SUBMITAL OF THE FINAL SAMPLING AND ANALYSIS PLAN FOR MONITORING OF NATURAL  
ATTENUATION AT IHSS 118.1 (RF/RMRS-98-252) - MCB-042-98

FINAL SAMPLING AND  
ANALYSIS PLAN FOR  
MONITORING OF NATURAL  
ATTENUATION AT IHSS 118.1

Response to DOE Comments on the IHSS 118.1 SAP

**Comments on**  
**Draft Sampling and Analysis Plan For Monitoring of Natural Attenuation at IHSS 118.1**  
**August 20, 1998 (Rev. 0)**

Figure 2-1 Decision Tree for IHSS 118.1 Natural Attenuation Sampling

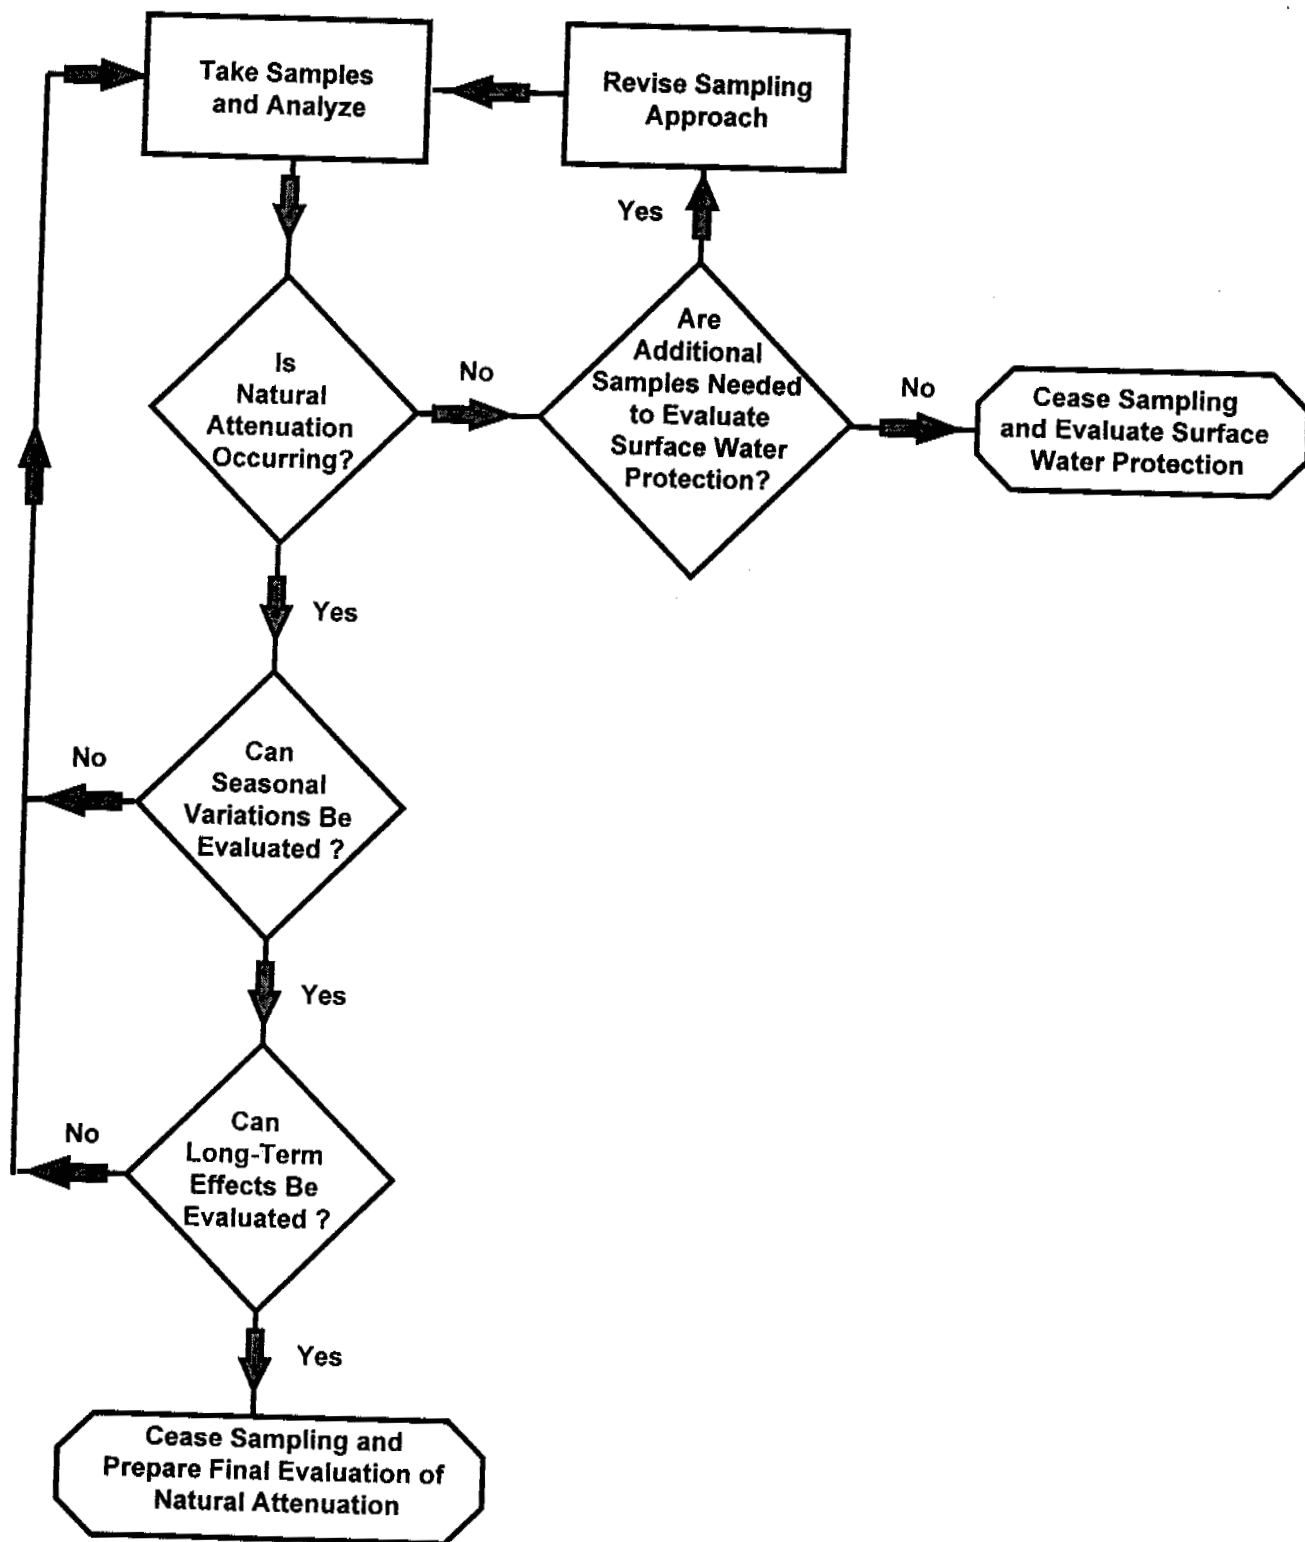
**Comment 7:** Page 9, Figure 2-1 the text reads as follows:

“Are Additional Samples Needed to Evaluate Surface Water Protection”

**Comment:** Another decision input for Sec. 2.3?

**Comment 8:** Page 9, Figure 2-1 the text reads as follows:

**Comment:** or are conditions amendable to Natural Attenuation?

Decision Tree in Figure 2-1:

Nothing is described between needing additional samples to evaluate surface water protection and the first action of taking samples. Without more detail, it suggests that taking the same sampling actions are all that are needed.

**Response:** *This comments points out a weakness in the decision, input since one of the key inputs for evaluating surface water protect is the footing drain sampling. Although the case could be made that this falls under groundwater chemistry, it would be better to define it as an additional input. Section 2.3 has been modified to reflect this additional input.*

**Response:** *Although the process for determining whether natural attenuation is occurring includes evaluating conditions that support natural attenuation is not a separate decision. If it can not be established that natural attenuation is occurring then there is no need to proceed even if the conditions amendable to natural attenuation are present. Based on the scoring system, this would be the case if a score lower than 14 is*

The decision tree has been revised to include a step to "Revise Sampling Approach."
